Urban Design Brief
Proposed Self-Storage Facilities
1015 Dairy Drive Ottawa, Ontario.

September 18th, 2024
Prepared By

7.0 Response to Pre-consultation Comments

Figure 10: Proposed site plan

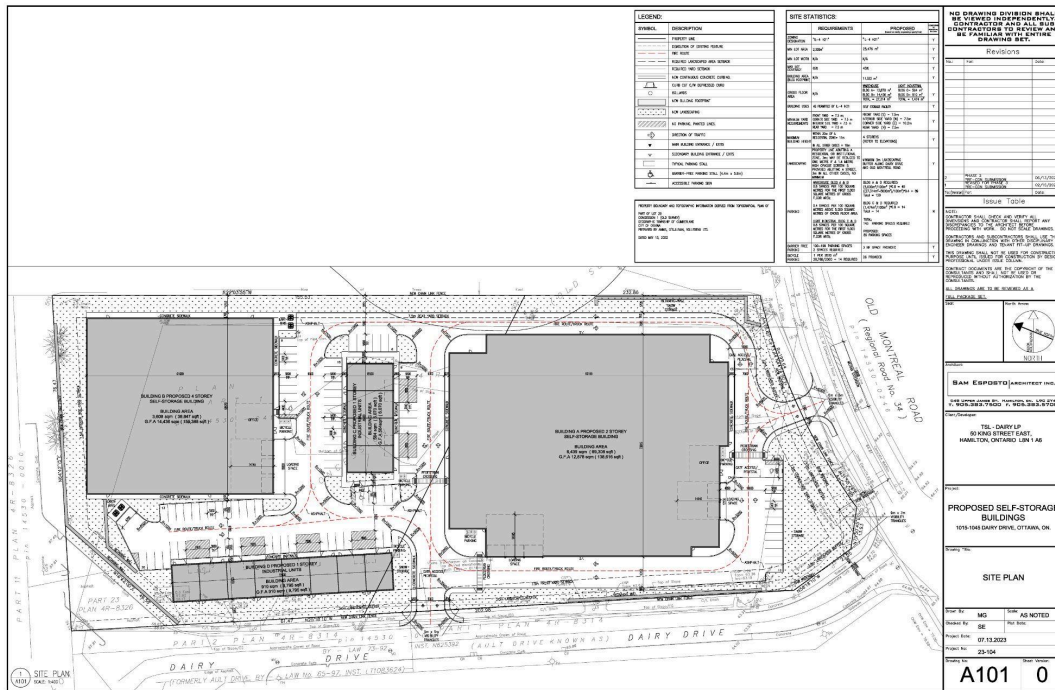
- b) Pedestrian access/safety: We recommend the parking area on Dairy Drive provide clear pedestrian marking through the drive aisles to any provided building access to ensure safety of pedestrians when in conflict with vehicles on the site.

- As seen on the site plan, the pedestrian walkways from internal sidewalks and parking areas have been identified through painted lines on the pavement. This provides clarity on where pedestrians can walk and ensures their safety.

Figure 14: Landscape plan showing placement of trees and plants to provide naturalized screening to improve the image of the fence surrounding the site and beautify entrances.

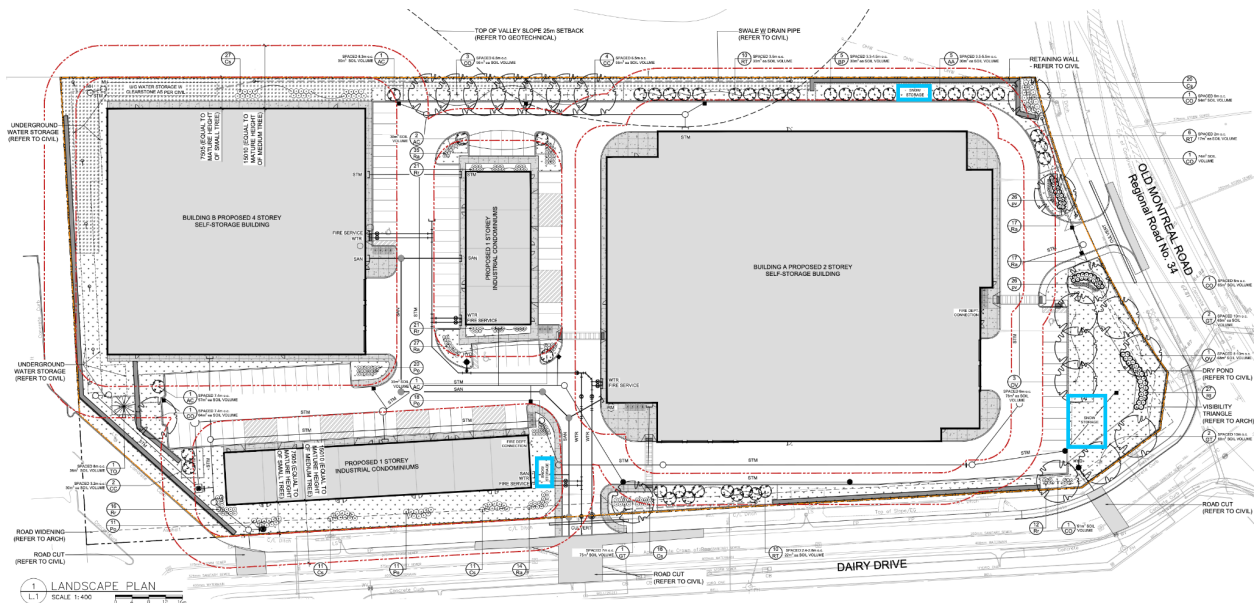
- a) Landscaping: We recommend the landscaping approach provide a naturalized screen between the street and the facility. See the property to the west for example.

- This comment has been taken into consideration and the landscape architect has designed the site landscaping to provide additional landscape screening to improve the image of the fence surrounding the site through the use of trees and natural features (figure 14).
